From: info@waipadc.govt.nz
Sent: Friday, 30 September 2022 4:07 pm
To: Policy Shared
Subject: External Sender: Waipā District Plan - Plan Change Submission Form 5 - Jay El Limited

This is a submission on the following proposed plan change to the Waipā District Plan
 #26 - Residential Zone Intensification

RE: Submission on Plan Change 26 – Residential Zone Intensification

Point 3 – Zone Map 39 – Te Awamutu (East)

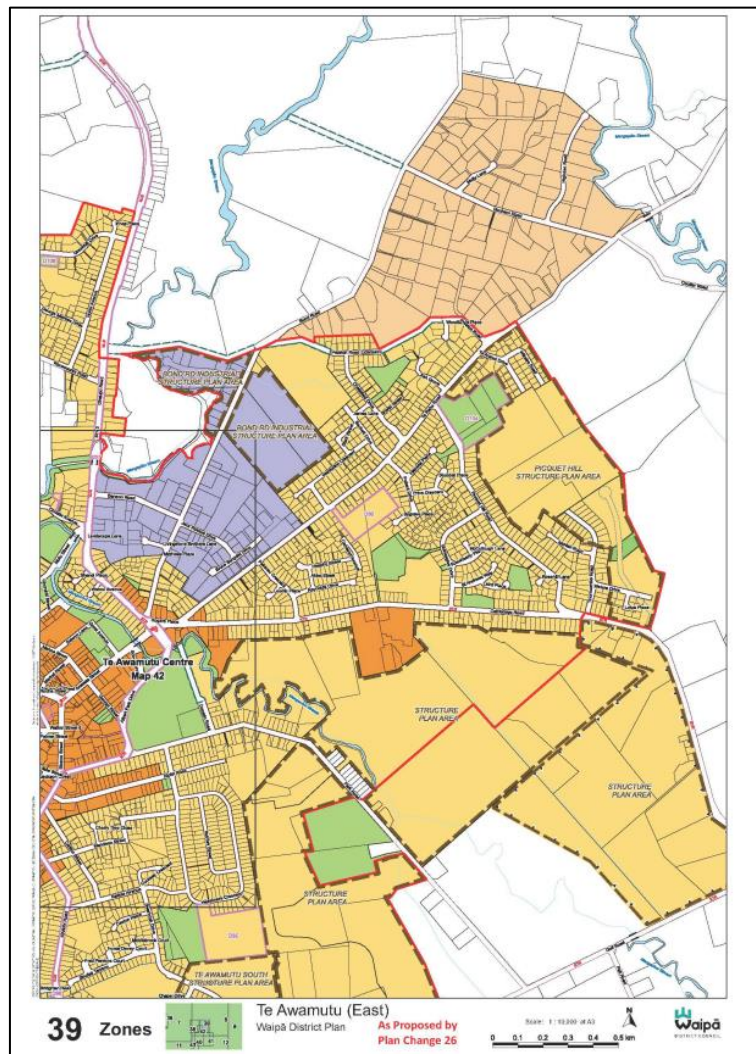
It is noted that there is a discrepancy between the Urban Limit on the proposed zoning map shown above and the extent of the zoning allowing residential development. Further, the above Urban Limit is not consistent with the location of it in the current zone and policy maps under the Operative District Plan, refer below. Namely, this discrepancy is located where the Urban Limit traverses the T11 growth cell. Please rectify this, which appears to be a simple mapping error.
